COMMUNITY DEVELOPMENT DEPARTMENT REPORT

HEARING DATE: 12/17/2024
TO: Mayor & City Council
FROM: Linda Ritter, Associate Planner
208-884-5533
lritter@meridiancity.org
APPLICANT: Laren Bailey, Conger Group
SUBJECT: H-2024-0023
Summerlin West Subdivision AZ, PP
LOCATION: Located in the NW ¼ of the SW ¼ of Section 5, Township 2N, Range 1E, parcels: R5147110200, R5147110324, R5147110342 and S1405315235

An annexation with zoning from RUT (Rural Urban Transition) to R-8 (medium density) and R-15 (medium-high density) and a preliminary plat application to allow for the development of a 367-lot subdivision consisting of 337 residential building lots and 28 common lots on 63.17-acres.

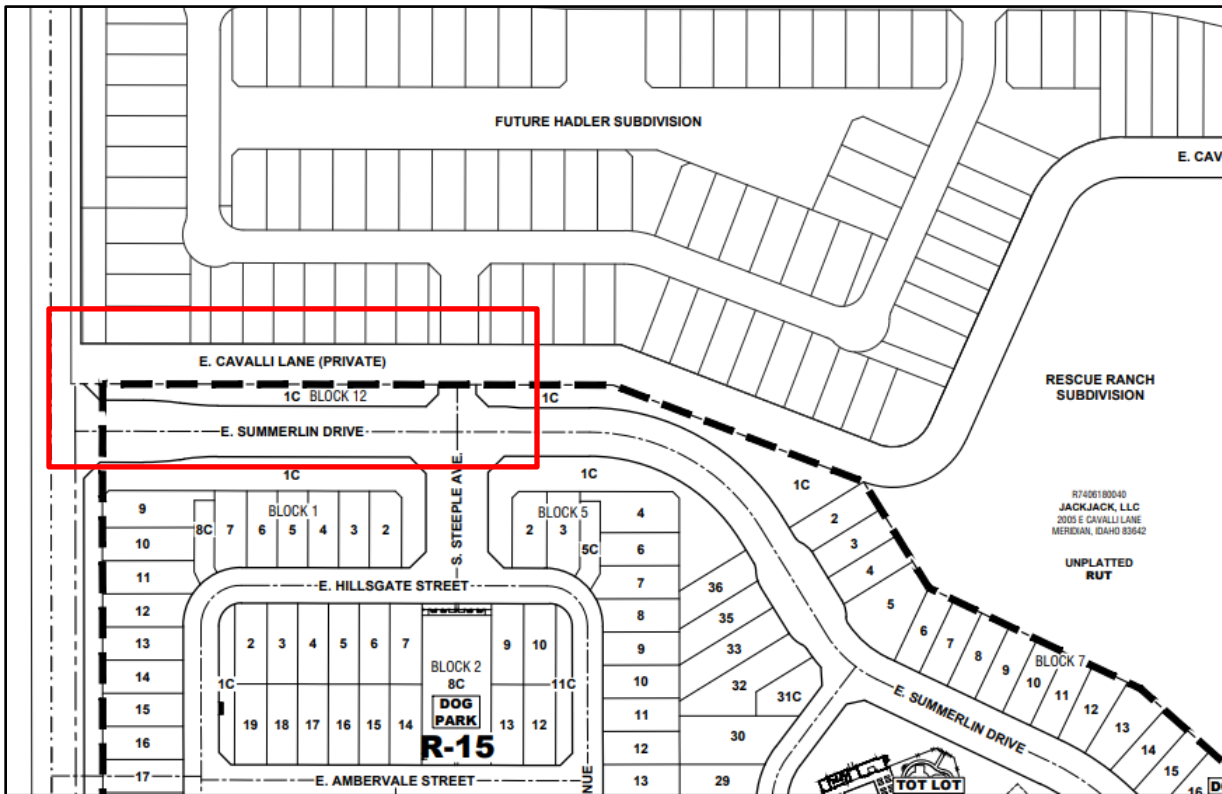
Staff has concerns regarding access management and potential impacts due to the close proximity of the private road (E. Cavalli Lane) to the proposed public road (Summerlin Drive). Staff feels the applicant and the adjacent property owner should coordinate to develop a shared access solution. A shared access point could potentially reduce traffic congestion and simplify entry/exit points, particularly for larger developments and not leave fifty (50) feet of undeveloped land. See image below.

E. Preliminary Plat (date: 10/10/2024)

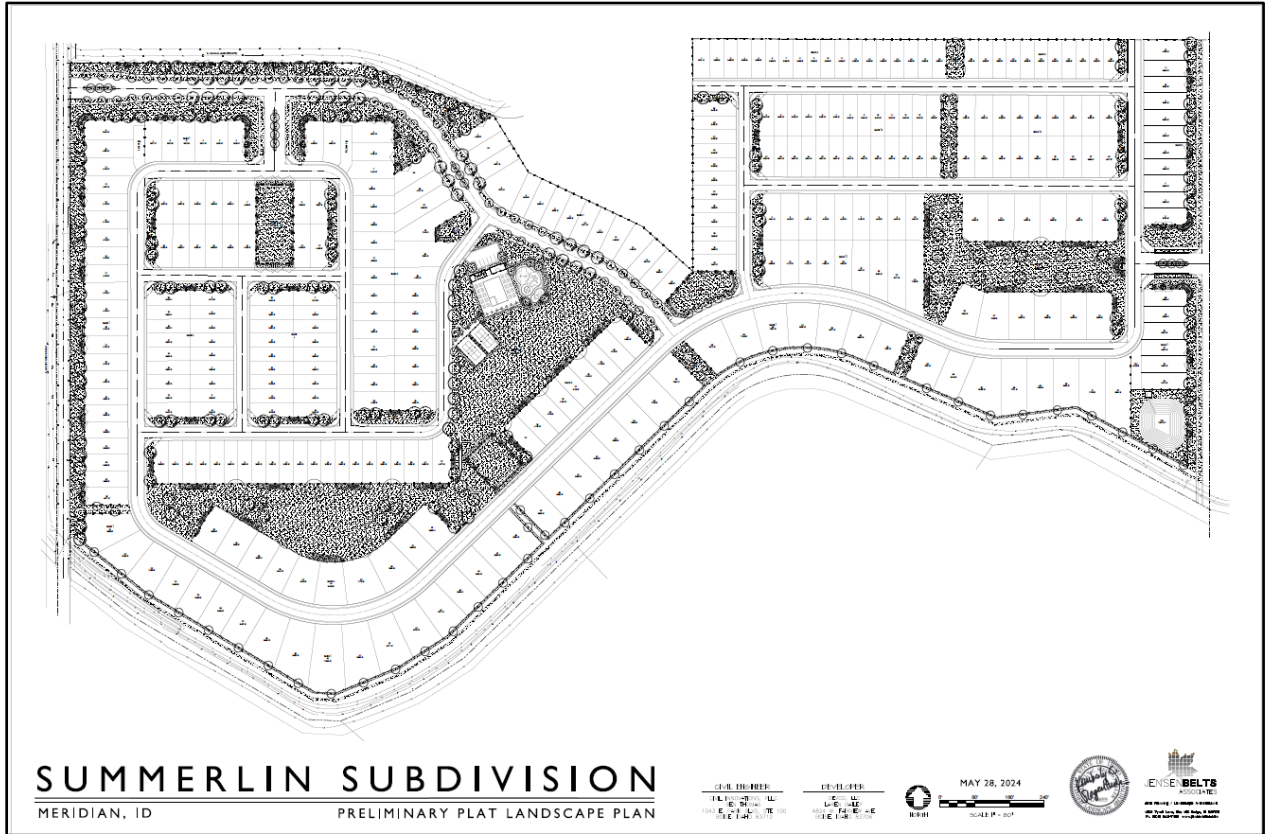
3. The Preliminary Plat included in Section VII, dated 10/10/24, is approved with the following revisions:
 - a. All utility easements reflected on the utility plan shall be included on the final plat.

- b. All pathways and micropathways shall be within a separate common lot or easement as required per UDC 11-3A-8.
 - c. Revise the plat map to shift to reflect R2 or R-4 zoning for lots 31-71, Block 1 and provide a legal description. Submit to the City fifteen (15) days prior to the City Council meeting.

- ~~d. Provide a stub road from E. Summerlin Drive to parcel# R8315200030.~~
 - e. Revise preliminary plat map to show the right-of-way dedication along S. Locust Grove Road.

F. Landscape Plan (date: 6/10/2024)

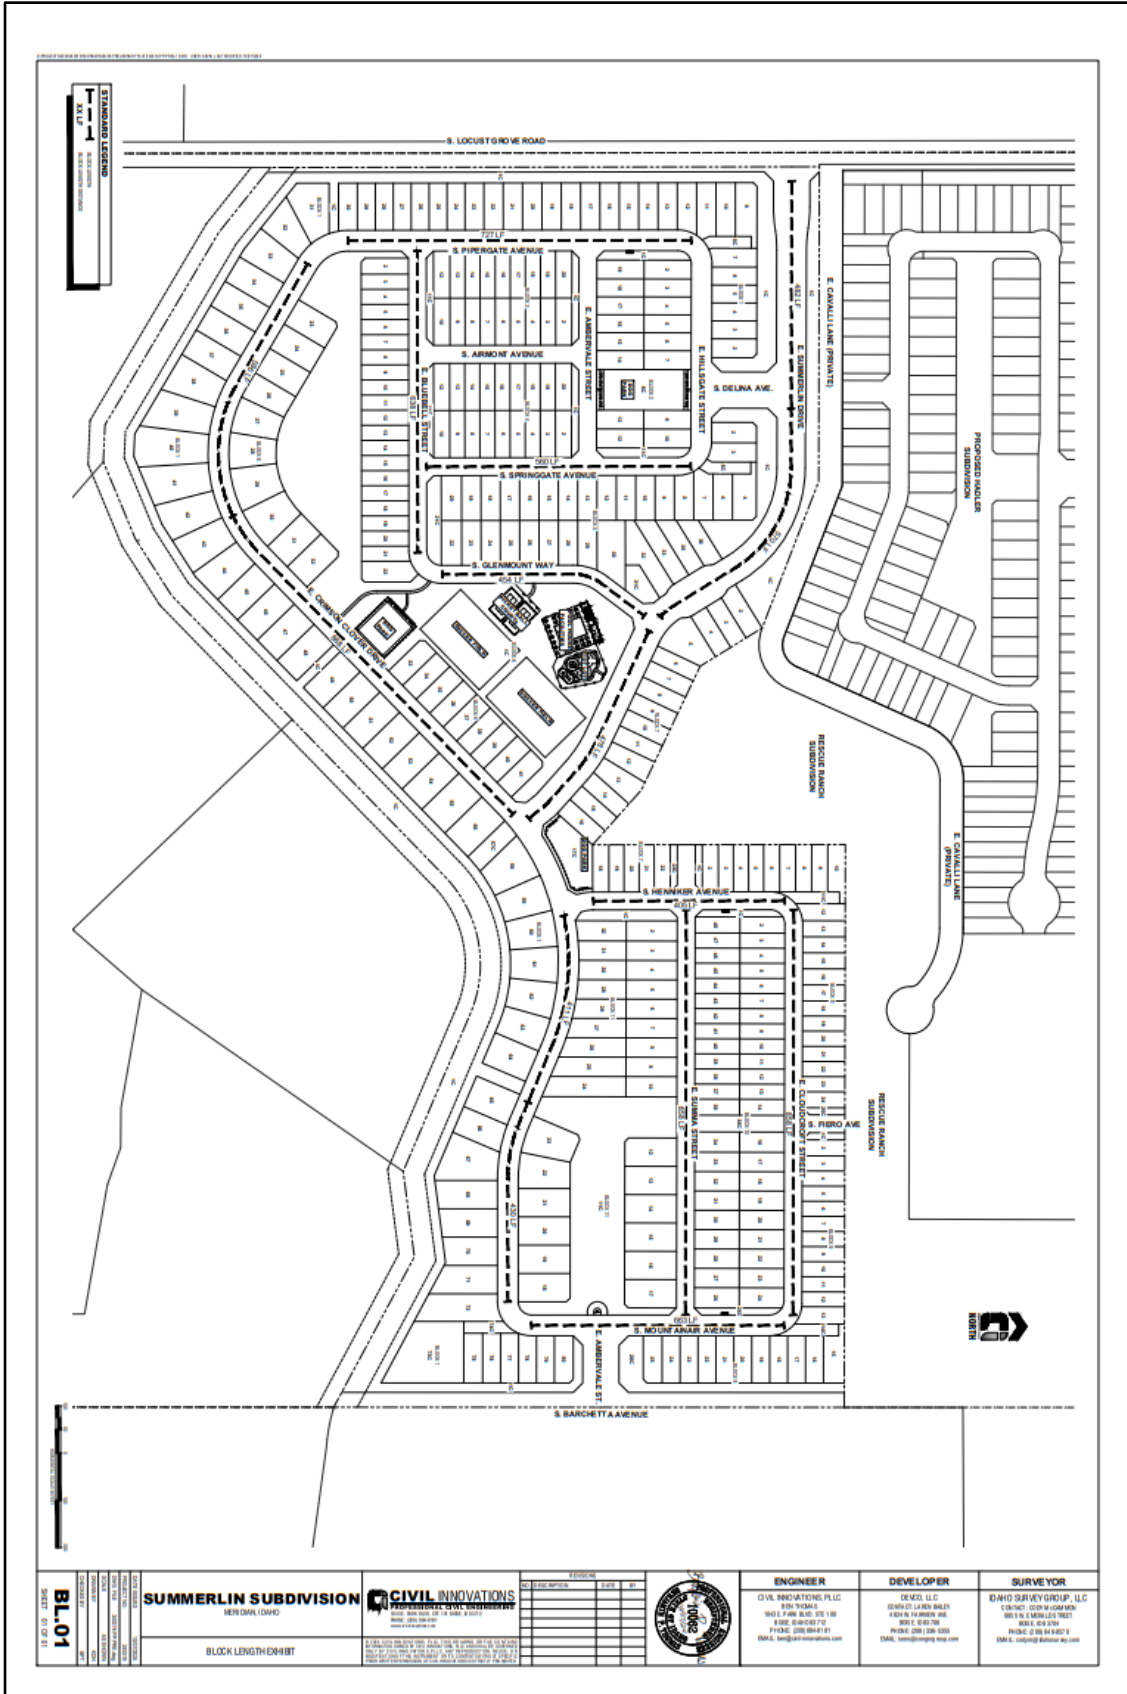
4. The Landscape Plan included in Section VII, dated 5/28/24, shall be submitted for review and approval with the following revisions prior to final plat approval:

- a. Show the ten (10) foot wide detached sidewalks along the east side frontage of Locust Grove Road and the west side frontage of Barchetta Avenue.
 - b. Add pathway landscaping along the south side of the Rawson Canal.

- c. Add shrubs/ornamental grasses/perennials to the pathway within Lot 1C, Block 1 and Lot 11C, Block 11.
